**CABINET MEMBER FOR HIGHWAY MANAGEMENT –
14 OCTOBER 2021**

**ASTON ROWANT: PROPOSED 20MPH SPEED LIMIT AND TRAFFIC
CALMING BUILD-OUTS**

Report by Corporate Director, Environment and Place

Drawing title
PROPOSED 20MPH SPEED LIMIT

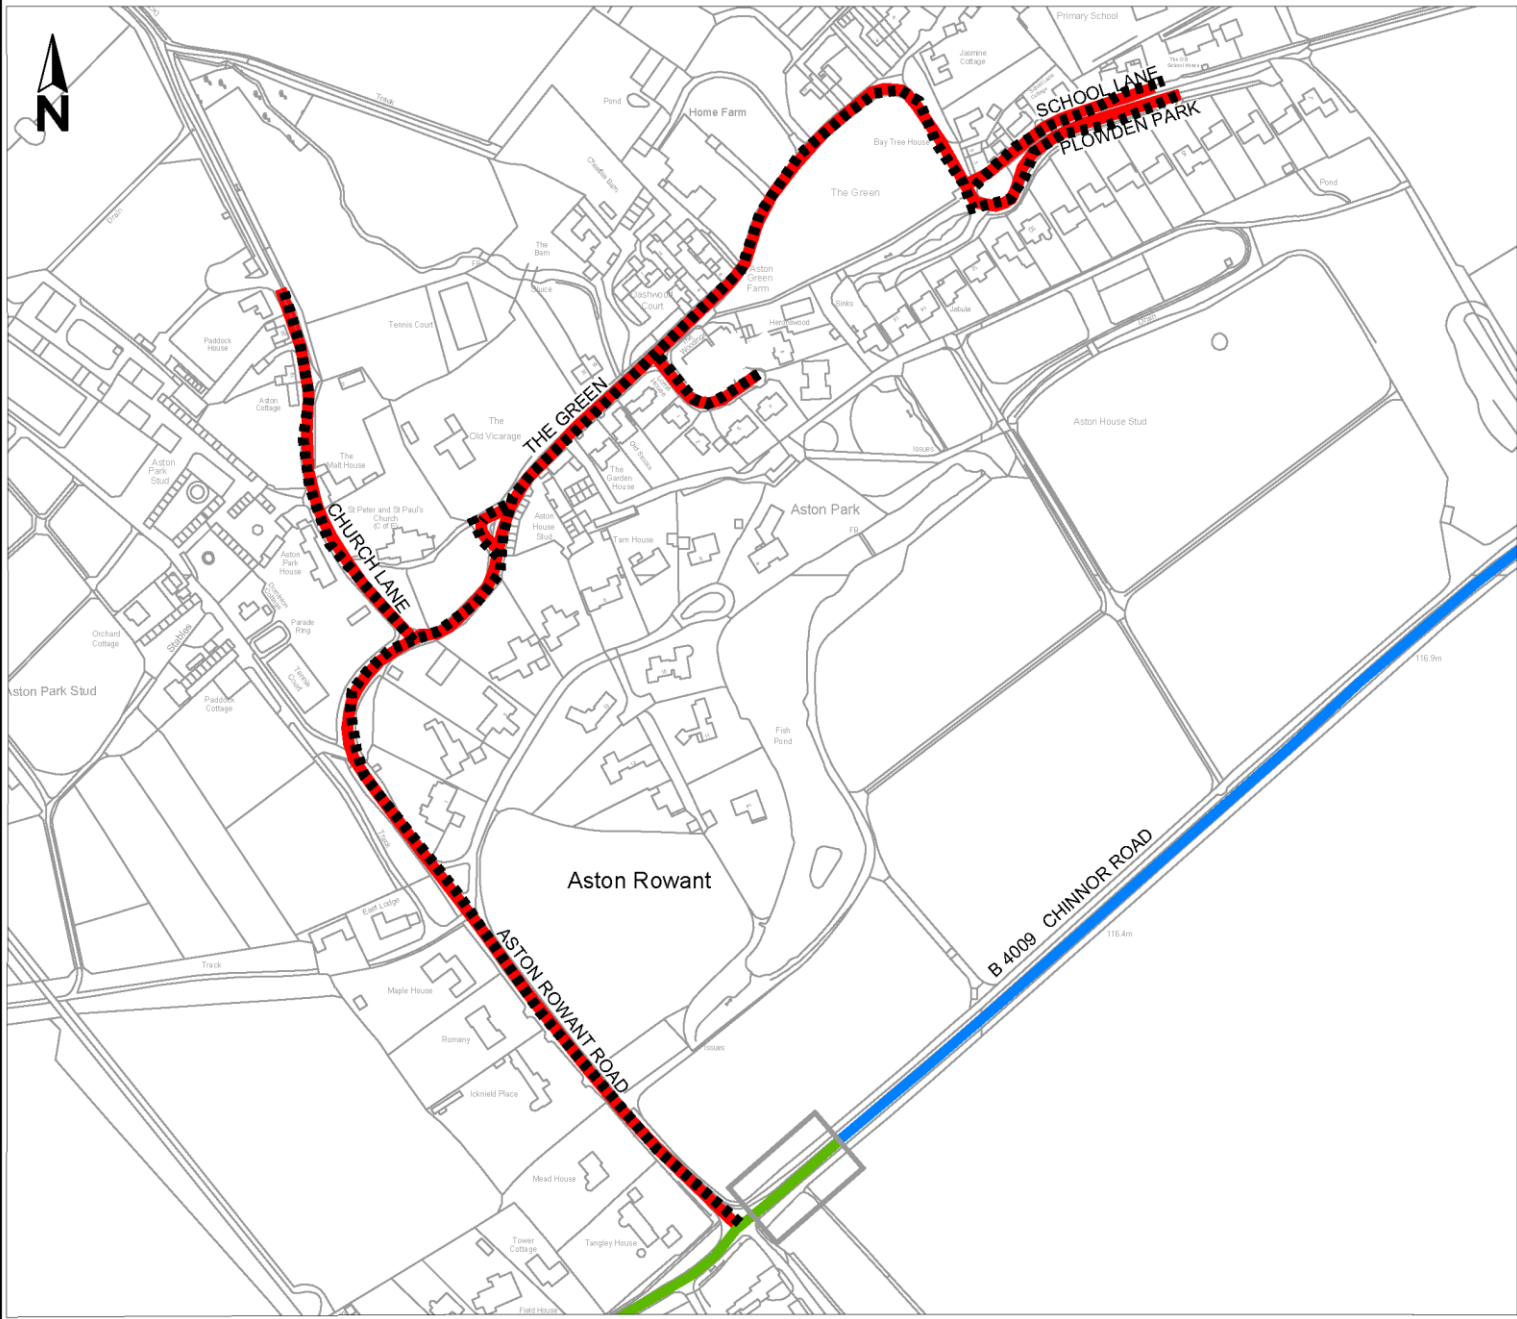
- d) The proposed 20mph limit in the village should be extended to include the road between the calming measures in both Aston Rowant and Kingston Blount.

This section of the B4009 Chinnor Road route is unsuitable for a 20mph limit. It has no frontage development, is straight with good forward visibility and would offer little justification to motorists for driving at that speed. It is currently subject to a 50mph limit.

Drawing Status: Draft
 Project Name: Aston Rowant - B4009 Traffic Calming

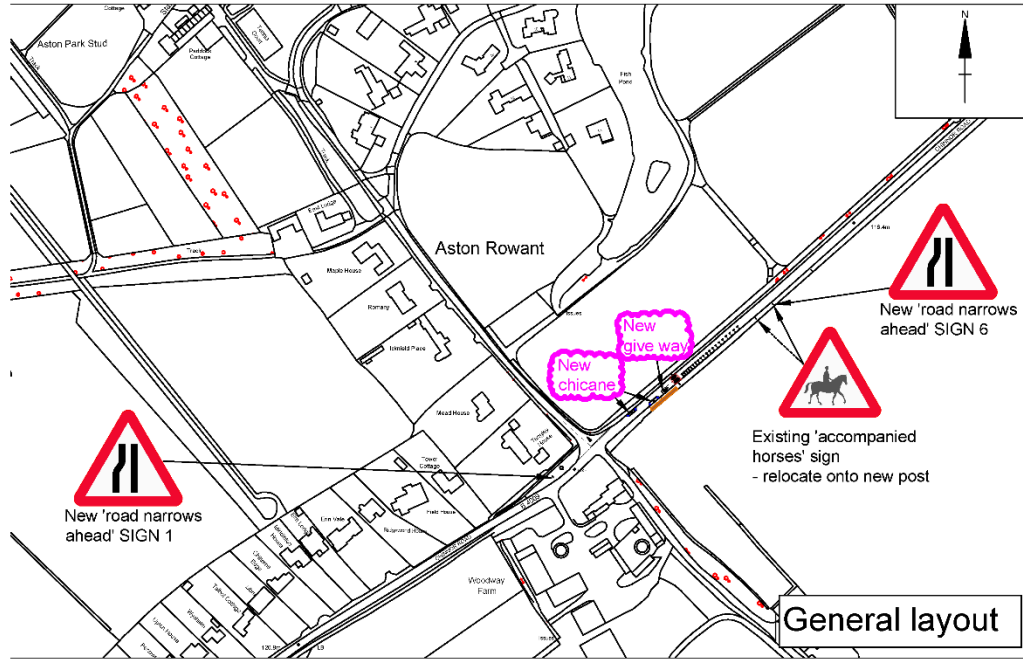
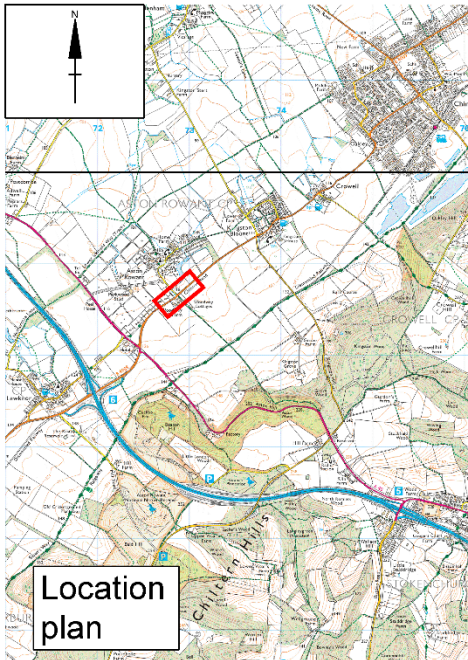
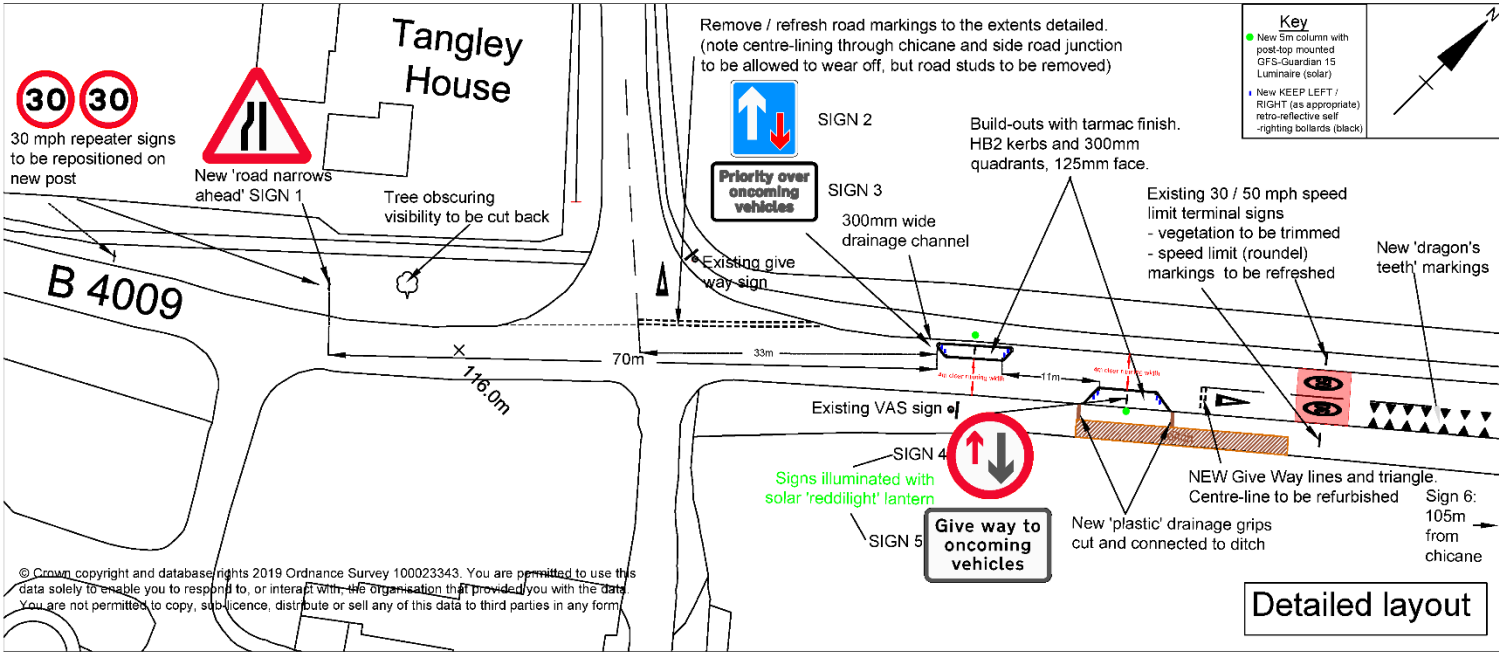
- a) Chicanes are too close to the junction with Aston Rowant Road.

- l) There can be flooding where the B4009 meets the road into the village. Has this new chicane given this due consideration? Best practice would be a drainage/cycle channel so cyclists don't have to ride through the chicane itself and it keeps rain water to the edges of the chicane.

The initial design for the chicane had located the first build-out 28m from the junction. Following an on-site trial of the build-outs, using temporary traffic cones, some traffic emerging from this side road had to pull-in due to there being oncoming traffic from the Chinnor direction traversing the chicane already. Consequently, this distance has now been extended to 33m to provide an extra car's distance to allow further space for vehicles to pull-in when emerging from the side road.

As indicated on the plan shown at Annex 2, drainage channels and 'grips' are proposed as part of the design of the chicane. It is not possible to provide a cycle 'bypass' at the chicane due to inadequate lateral width. Recent Department for Transport guidance on such features would reduce the remaining width available for the build-outs themselves.

Rev	Date	Description	By	Check
MH	10-08-21	Chicane repositioned 5m east and grips added for drainage on south side	MH	LJT
0	05-07-21	First Issue	MH	LJT
